**REPORT ON INDEPENDENT  
ANALYSIS AND ADVICE  
REGARDING THE SAFETY CASE  
ADDENDUM**

**FINAL VERSION**

**Doel 3**  
**Reactor Pressure Vessel  
Assessment**

**Figure 2.1: Size of the largest flaws with 20° inclination potentially not reported by UT inspection**

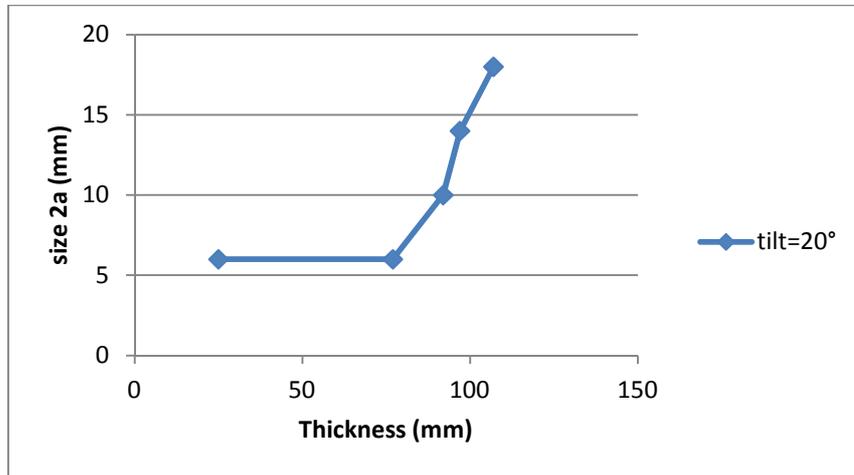
The Safety Authorities requested the performance of a sensitivity study of mechanical integrity. An envelope curve for the size of a potentially unreported flaw was determined in order to obtain a realistic basis to add potentially unreported flaws. Based on that input, the Project Team simulated various flaw configurations (orientation, size, tilt). The curve below represents the maximum size of a potentially unreported flaw with a conservative 20° tilt. This is the main input for the sensitivity analyses (see Chapter 5.3).

- The calculation of an envelope curve to define the size of the largest flaws with respect to the depth inside the material that would potentially not have been reported (see Figure 2.1). This relies on a deterministic approach and does not need to be penalized again.
- The use of a statistical and probabilistic tool in order to define the distribution of the additional postulated flaws.

The SCP Review Team endorses the conclusion of the Project Team that the 2012 straight beam UT inspections correctly detected and sized all hydrogen flakes in the VB395/1 block.

Figure 5.1: Flaw-screening criterion applied to core shells of Doel 3

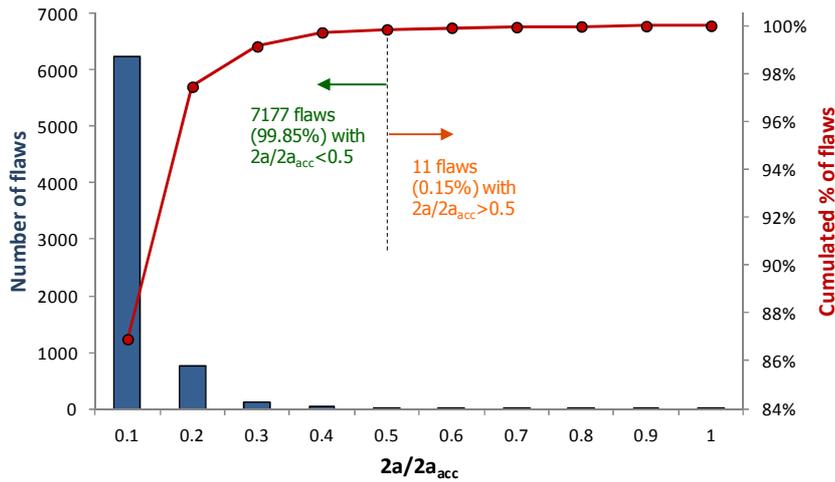
Applying the flaw-screening criterion to the flaws detected in the RPV core shells of Doel 3 shows that eleven flaws (isolated or grouped) exceed the flaw-screening criterion, as illustrated in Figure 5.1:

Figure 5.2: Ratio  $2a/2a_{acc}$  as a function of ligament for flaws exceeding the screening criterion

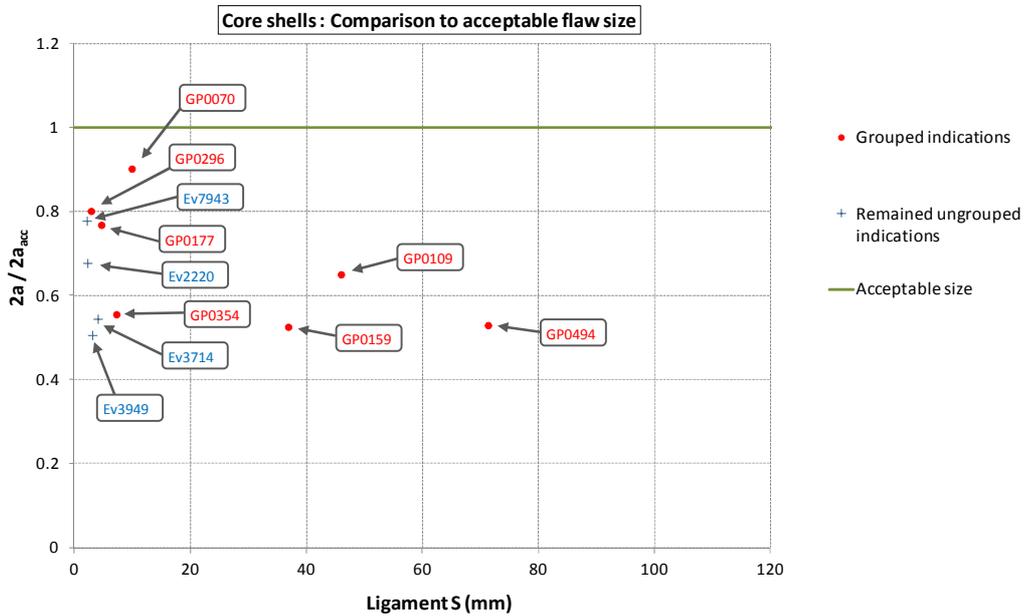
However, as Figure 5.2 shows, these flaws or groups of flaws meet the acceptability criterion (i.e. the ratio  $2a/2a_{acc} < 1$ ). In conformity with the flaw-screening approach, refined analyses were performed. They revealed substantial margins: the margin with respect to the  $2a/2a_{acc}$  ratio increases from 40% to more than 70% according to the six 3D-analyses that were performed on six configurations representative of the eleven considered here.

Figure 5.2 visualizes the flaws or groups of flaws taken into account in the analysis. The acceptability criterion (i.e. the ratio  $2a/2a_{acc} < 1$ ) is respected in every case, as shown in Table 5.1.

The flaw-screening criterion approach proposed in the FANC's Provisional Evaluation Report is in line with the request made in 2012 by the SCP Review Team to perform 3D calculations for all grouped and isolated flaws close to the acceptable flaw size. This request was based on the critical review by Sandia National Laboratories (SNL) regarding the proposed grouping criteria and their concern about the way to take into account the effect of the surrounding flaws on an isolated flaw.

The refined analyses performed by the Project Team are relevant and demonstrate the conservativeness of the Structural Integrity Assessment. It correctly addresses the concerns expressed by SNL.

**Figure 5.3: Doel 3 core shells, comparison to acceptable flaw size (SI water at 30 °C)**

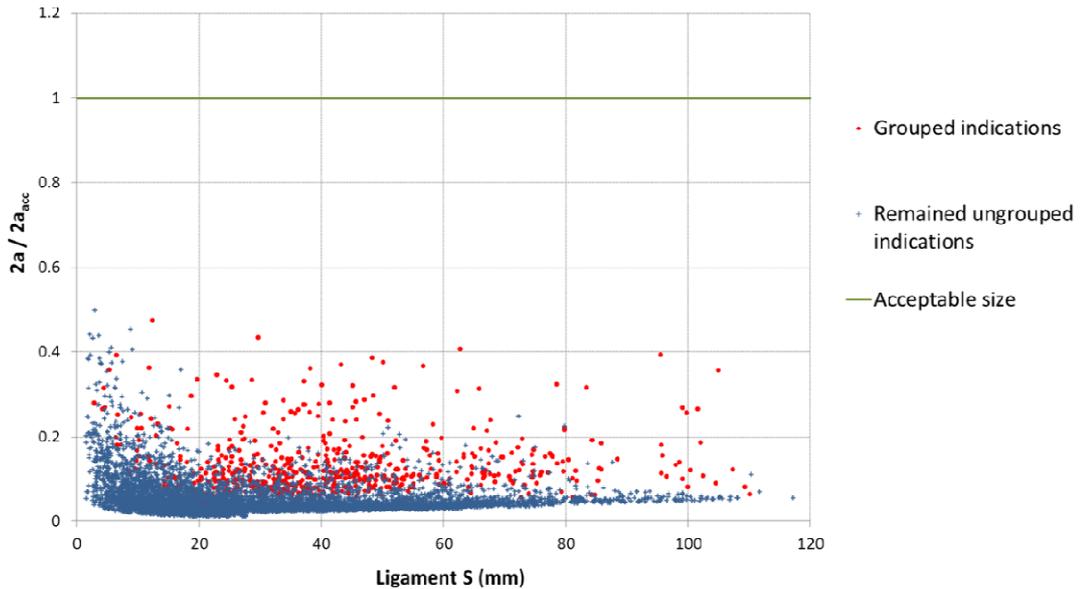
The refined analyses also take into account an increase in the Safety Injection (SI) water temperature, foreseen as an operational measure for the Doel 3 RPV in the 2012 Safety Case. This Defense-in-Depth decision was already supported by the SCP in its 2012 advice report regarding the Doel 3 RPV Safety Case. Indeed, in the Doel 3 RPV, most of the flaws close to the acceptable flaw size are located near the inner surface, which is not the case for the Tihange 2 RPV.

Finally, the SCP Review Team confirms its confidence in the demonstration of the structural integrity of the Doel 3 RPV, since the results of the refined analyses (see Figure 5.3), show a margin higher than 50 % with respect to the acceptability criterion ( $2a/2a_{acc} < 1$ ).

The SCP Review Team has no comment or remark regarding the Flaw Acceptability Analysis.
